MODIFICATION BULLETIN NO. LHO-001ISSUED ON Sep. 14, 1994

Model	LHO (MV715)			Date of Modification	
Modified Article				Execution Date	
Reason for Modification	<input type="checkbox"/> Parts catalog correction <input type="checkbox"/> Vendor change	<input type="checkbox"/> To meet standards () <input checked="" type="checkbox"/> Part standardization	<input type="checkbox"/> To facilitate assembly <input type="checkbox"/> To improve reliability <input type="checkbox"/> Other	After the old part has become out of stock.

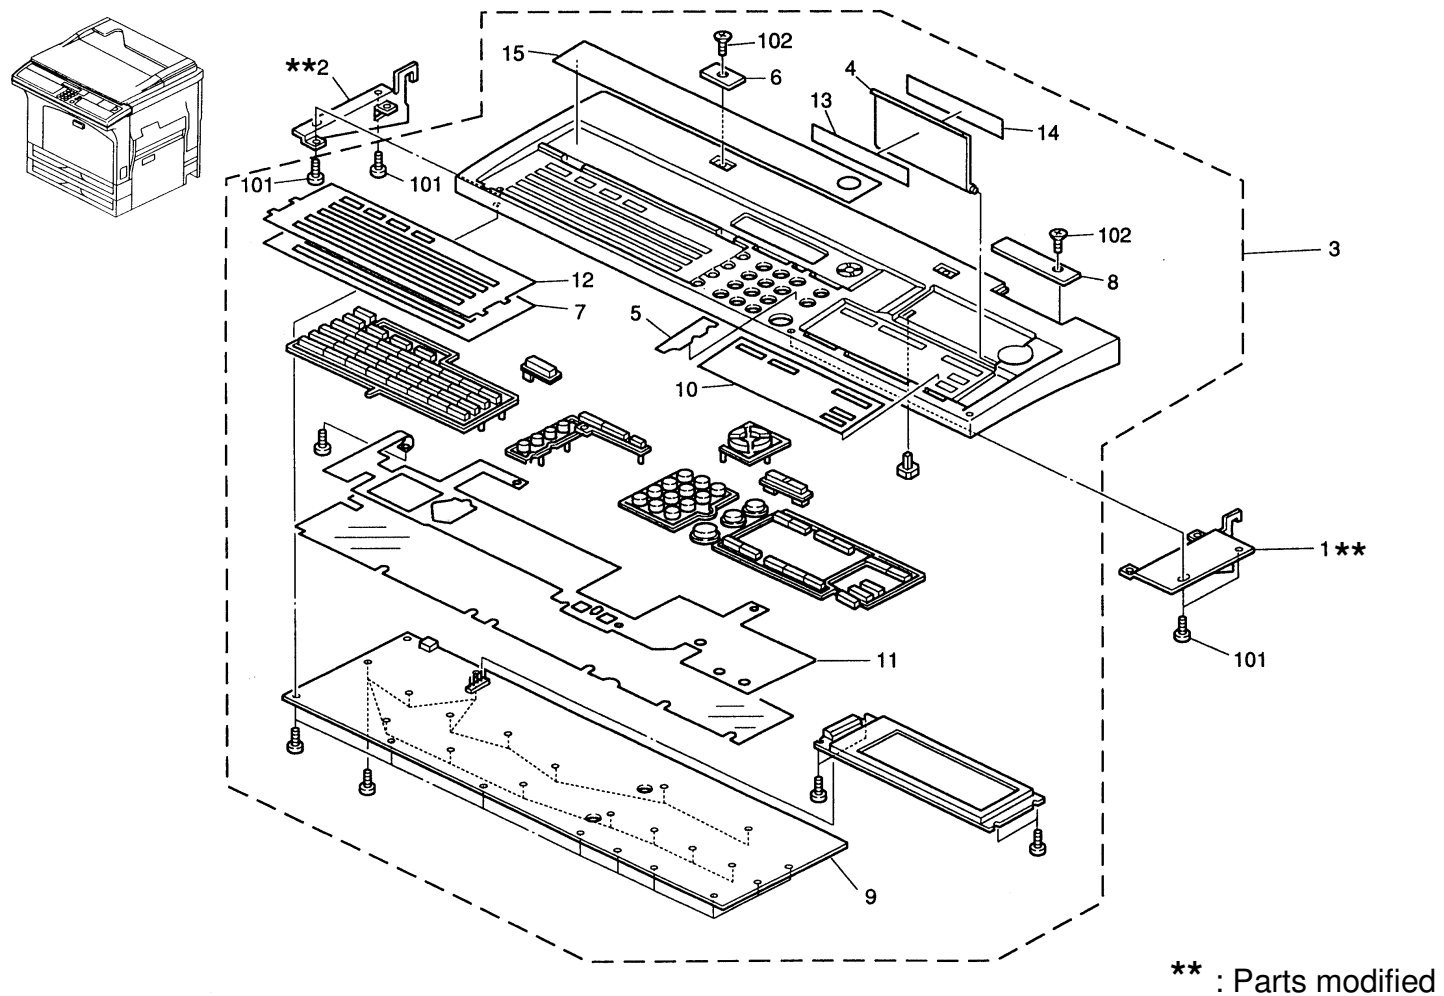
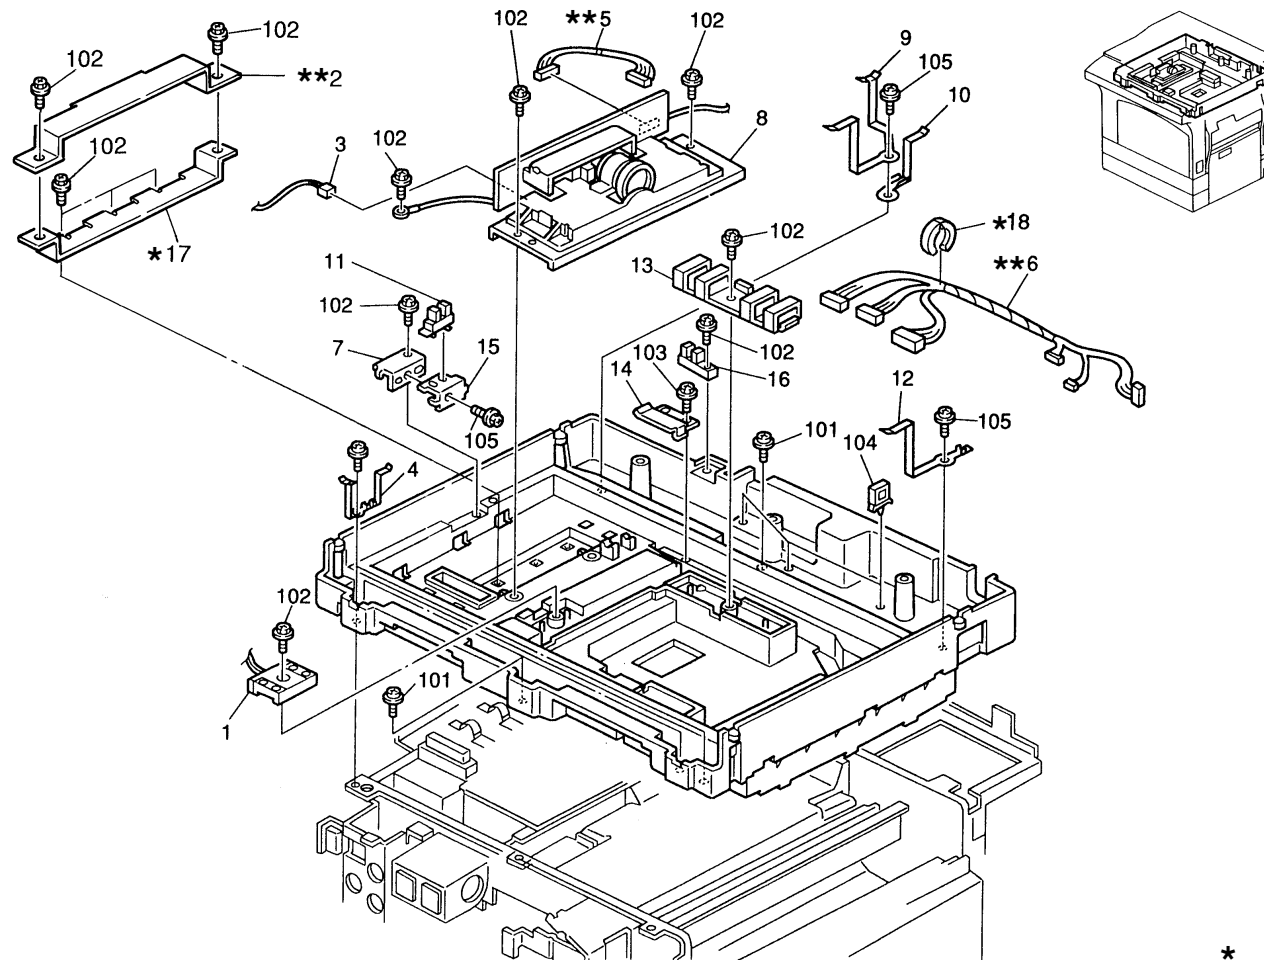
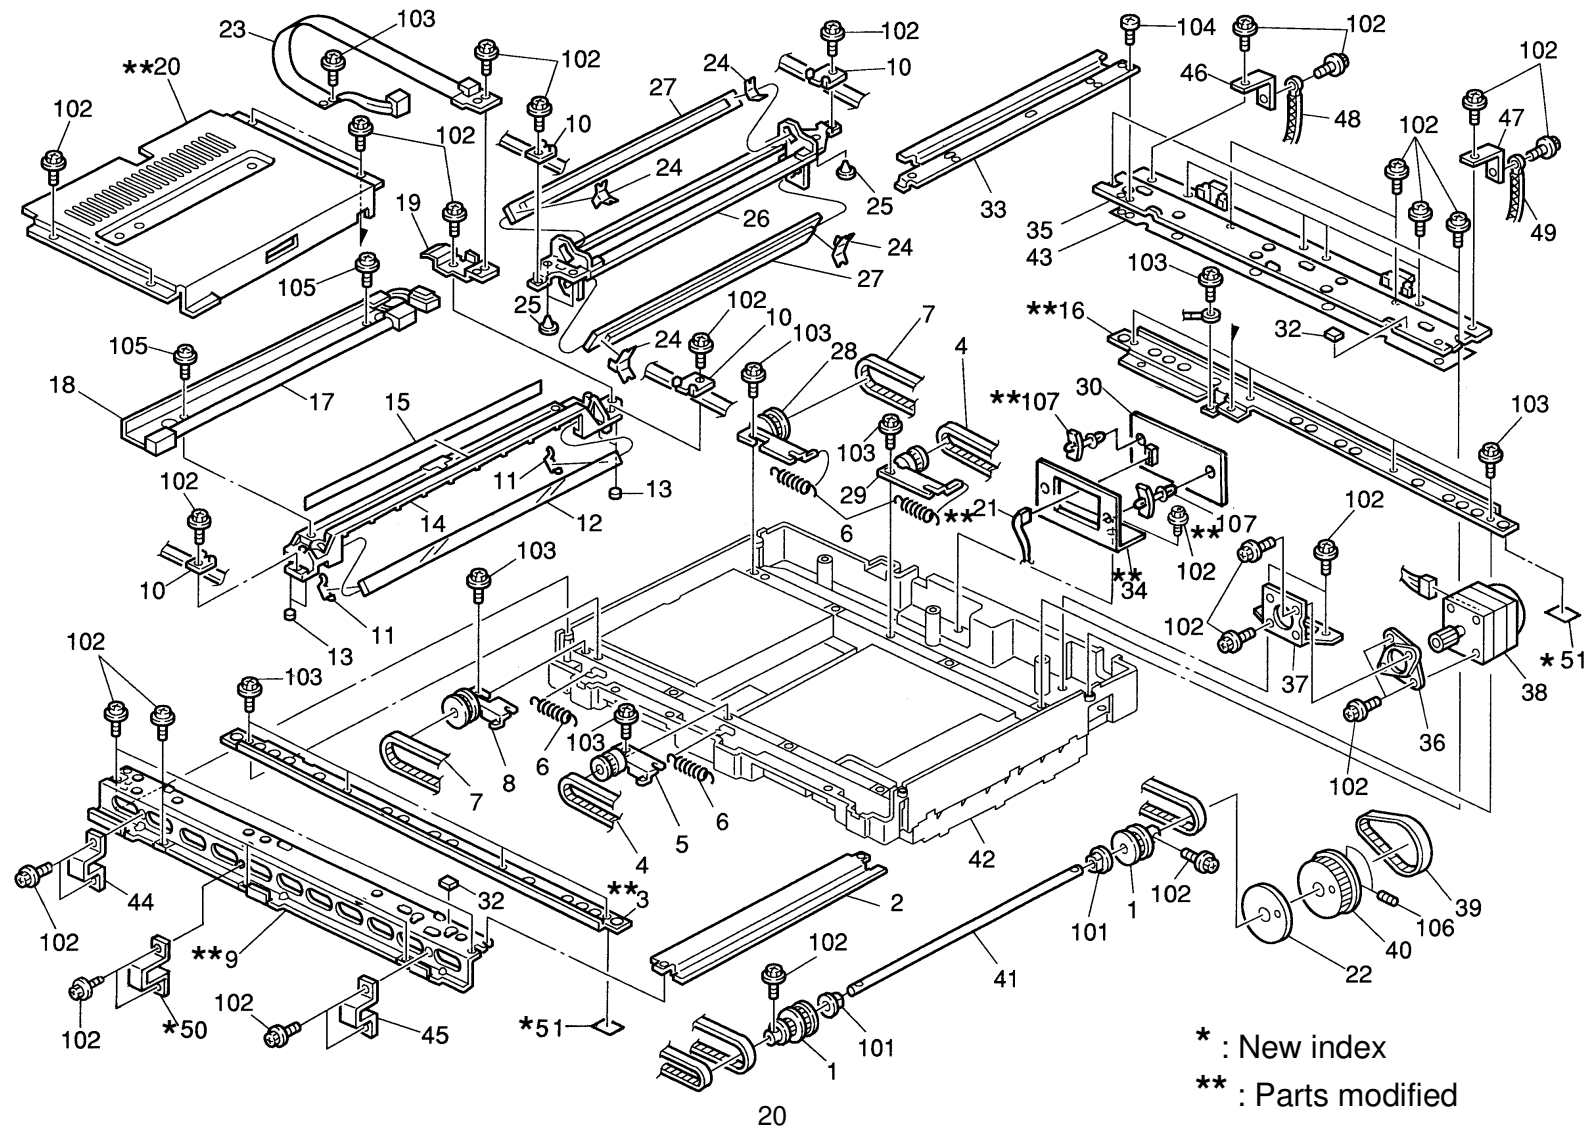
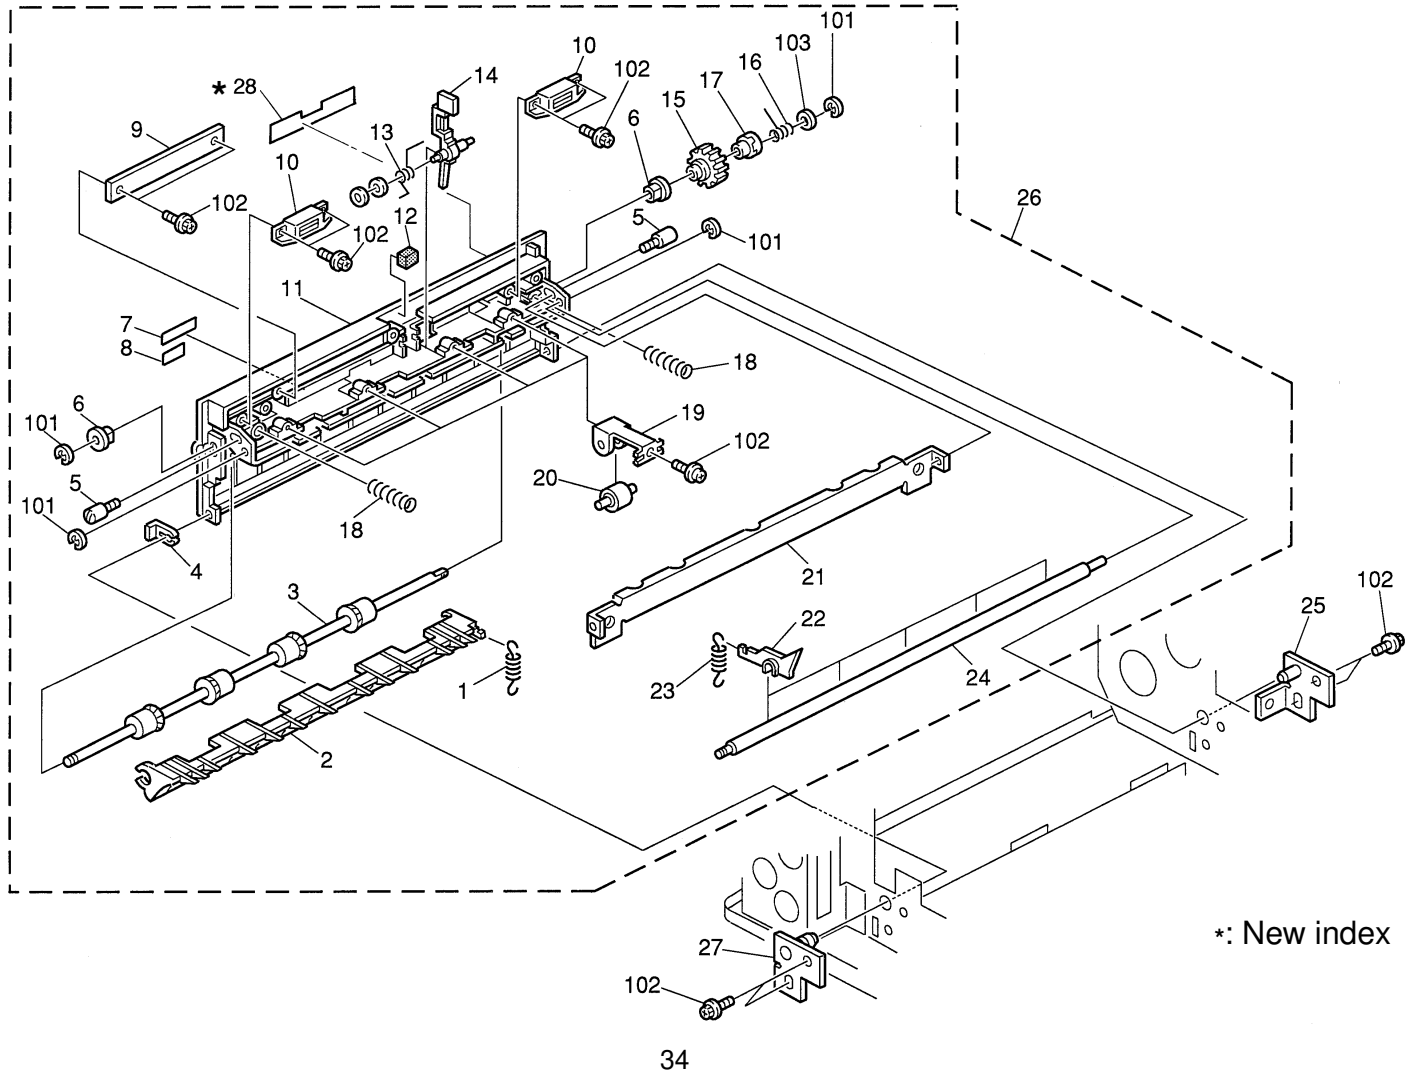
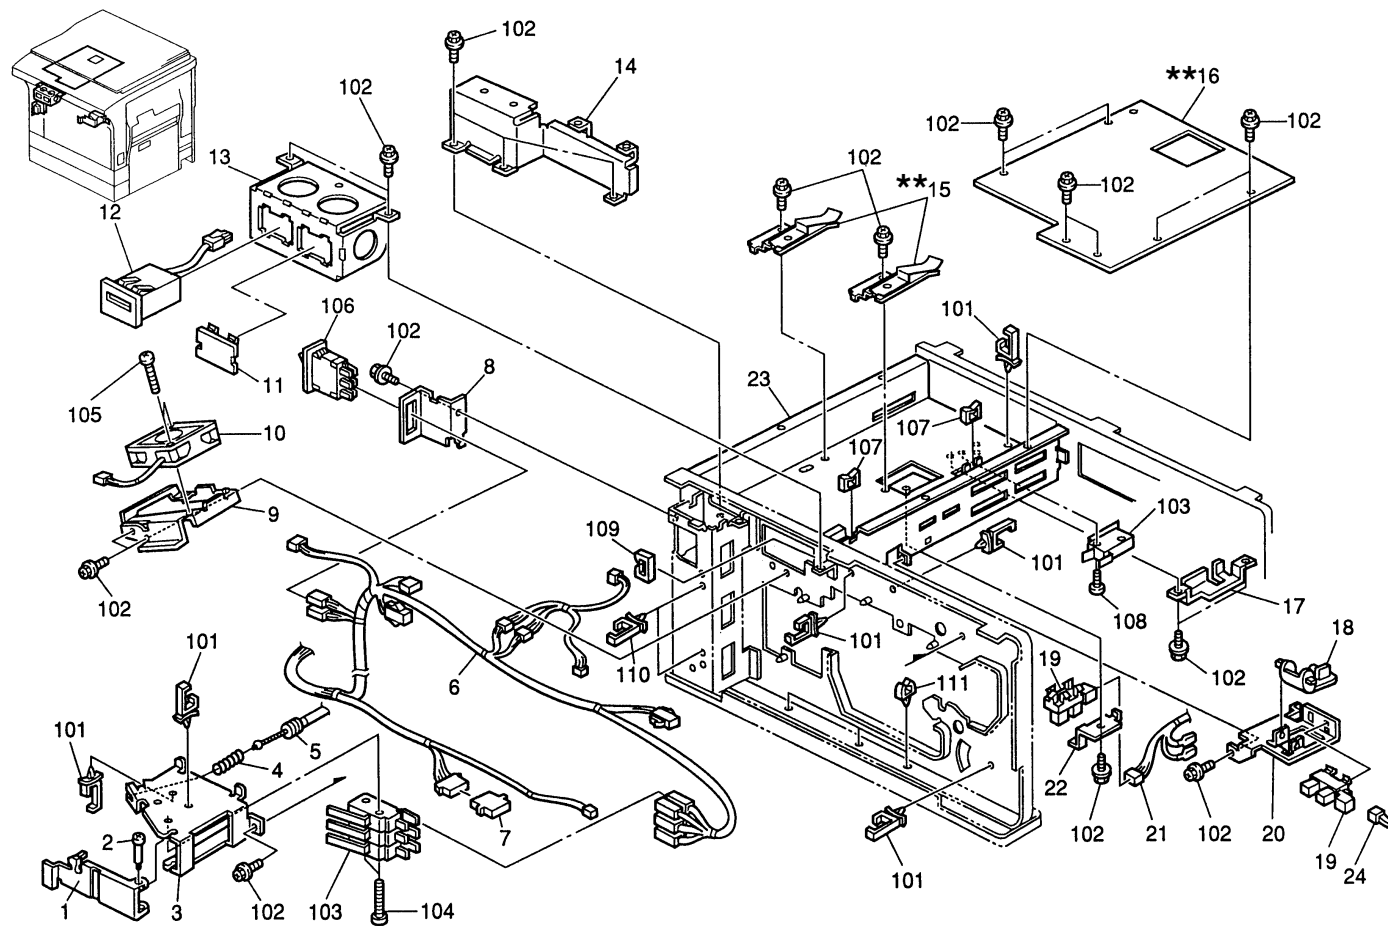
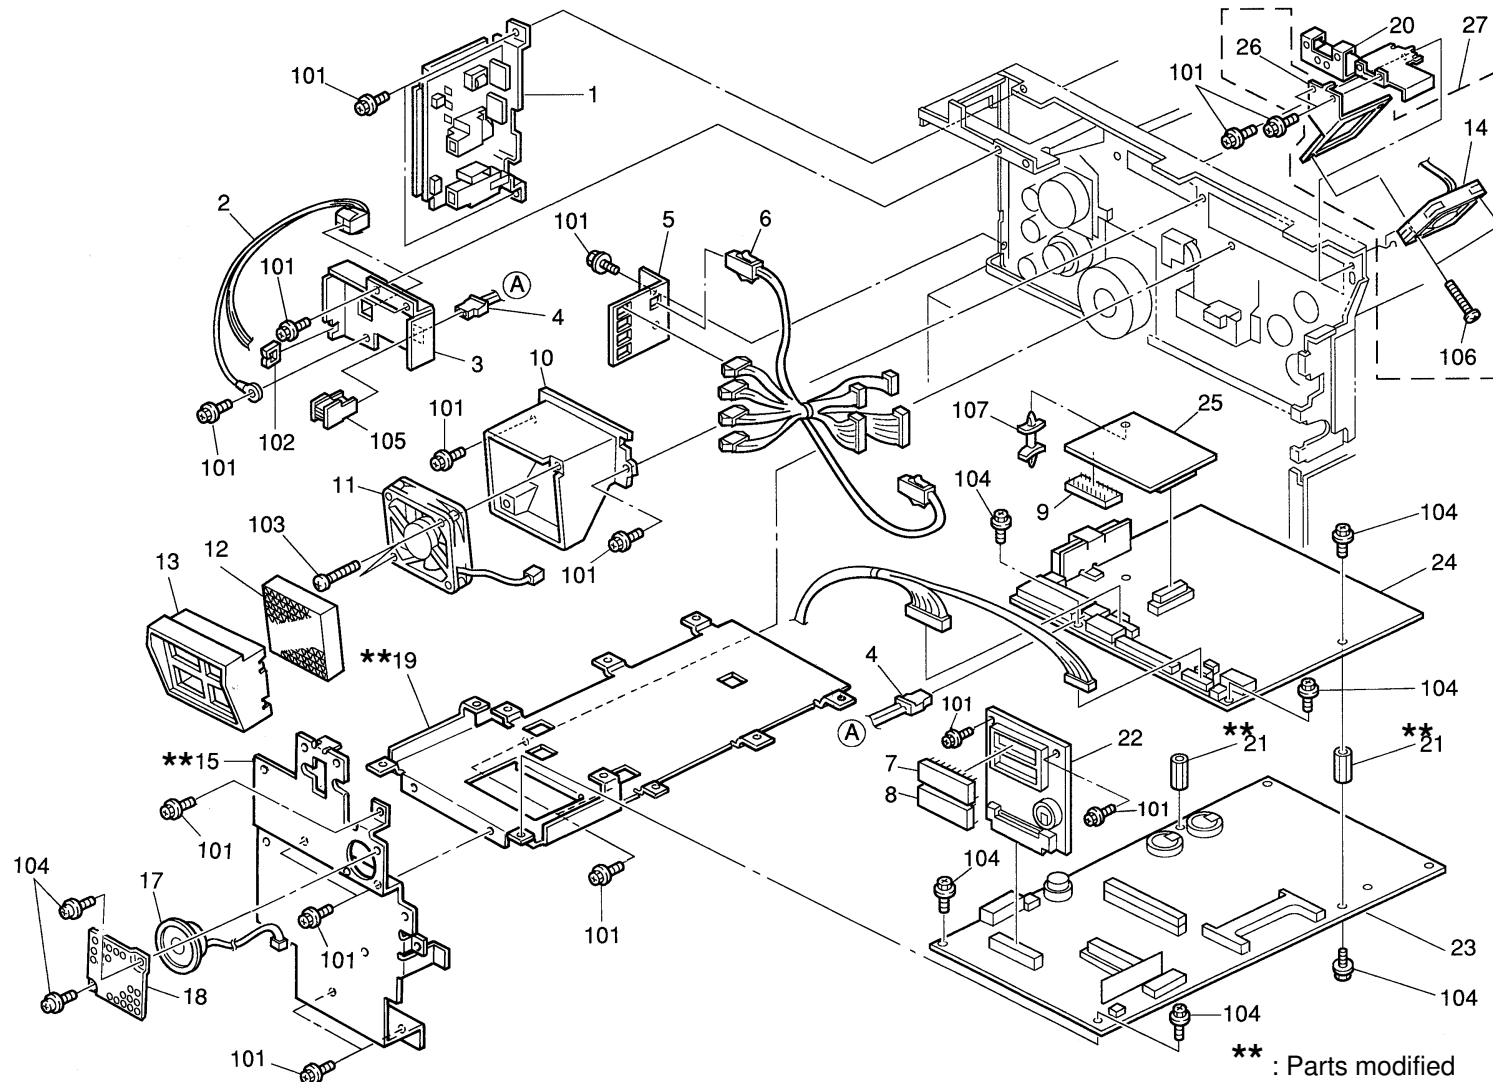
Model	LHO	Date of Modification
Modified Article	LHO Main Frame and ADF	Execution Date
Reason for Modification	<input type="checkbox"/> Parts catalog correction <input type="checkbox"/> To meet standards () <input type="checkbox"/> To facilitate assembly <input type="checkbox"/> Vender change <input type="checkbox"/> Part standardization <input type="checkbox"/> To improve reliability <input checked="" type="checkbox"/> Other	A120-22: 8915020141 A120-27: U8050200001 A120-30: F0650200001 A546-30: W1150200001 (ADF) A546-20: W0950200001 (Sorter)
To meet the Radis Interference Regulation (EN55022 Class B) in Europe, the parts in the table below have been modified. Refer to RTB No.LHO-012 issued on March 15, 1995 for the installation procedure. Note: There is no change to A120-15, -17, and -19 models.

Old Part No.	New Part No.	Description	Q'ty Used Old → New	Interchange-ability	Remarks	Parts Catalog	
						Index No.	Page
H5201115	H5201618	Right Bracket - Operation Panel - 230V	1 → 1	X / O		1	7
H5201114	H5201617	Left Bracket - Operation Panel - 230V	1 → 1			2	7
H5205017	H5205039	Operation Panel Ass'y - 230V	1 → 1	O / O (X / O in Switzerland and Sweden)		3	7
H5201606	H5201625	Scanner Inner Cover - 230V	1 → 1	X / O		2	19
A1001832		Ground Plate - Front	1 → 0			4	19
H5205330	H5205372	Harness - SBU - 230V	1 → 1	O / O (X / O in Switzerland and Sweden)		5	19
H5205304	H5205371	Harness - Optical Unit - 230V	1 → 1			6	19
A1001835		Earth Plate - Frame Rear Left	1 → 0			9	19
A1001834		Earth Plate - Side Rail - Rear Left	1 → 0			10	19

Old Parts No.	New Parts No.	Description	Q'ty Used Old → New	Interchange- ability	Remarks	Parts Catalog	
						Index No.	Page
A1001833		Earth Plate - Side Rail - Rear Right	1 → 0			12	19
A1002116		Harness Holder	1 → 0			14	19
	H5201621	Cover - SBU	0 → 1		*: New Index	*17	19
	16070576	Sleeve Core	0 → 1			*18	19
H5201604	H5201627	Slide Rail - Front - 230W	1 → 1			3	21
A1001801	H5201624	Frame Front - 230V	1 → 1	X / O		9	21
H5201605	H5201628	Slide Rail - Rear - 230W	1 → 1			16	21
A1001837	H5201626	Inner Cover - CCD - 230V	1 → 1			20	21
H5205328	H5205370	Xenon Lamp Harness - 230V	1 → 1	O / O (X / O in Switzerland and Sweden)		21	21
H5201613		Bracket - Stabilizer	1 → 0			31	21
H5201612	H5201116	Cover - Stabilizer - 230W	1 → 1	X / O		34	21
H5205361		Grounding Wire - Rear Left	1 → 0			48	21
H5205360		Grounding Wire - Rear Right	1 → 0			49	21
	H5201619	Ground Plate	0 → 1			*50	21
	H5201620	Film - Slide Rail	0 → 2			*51	21

11050214	H5201117	Spacer - 230V	2 → 2	X / O		107	21
	H5152184	Decal - Warning	0 → 1			*28	35
A1005811	H5202637	Modular Cord Bracket - 230V	1 → 1	X / O		14	37
H5203105		Bracket - Left Rear Cover	1 → 0			15	37
H5203132	H5202639	Bracket - FCU - 230V	2 → 2	X / O		15	41
H5203146	H5202635	Cover - PCB Case - 230V	1 → 1			16	41
H5203135	H5202631	Speaker Bracket	1 → 1			15	43
H5203137		Spacer MBU Support Bracket	1 → 0			16	43
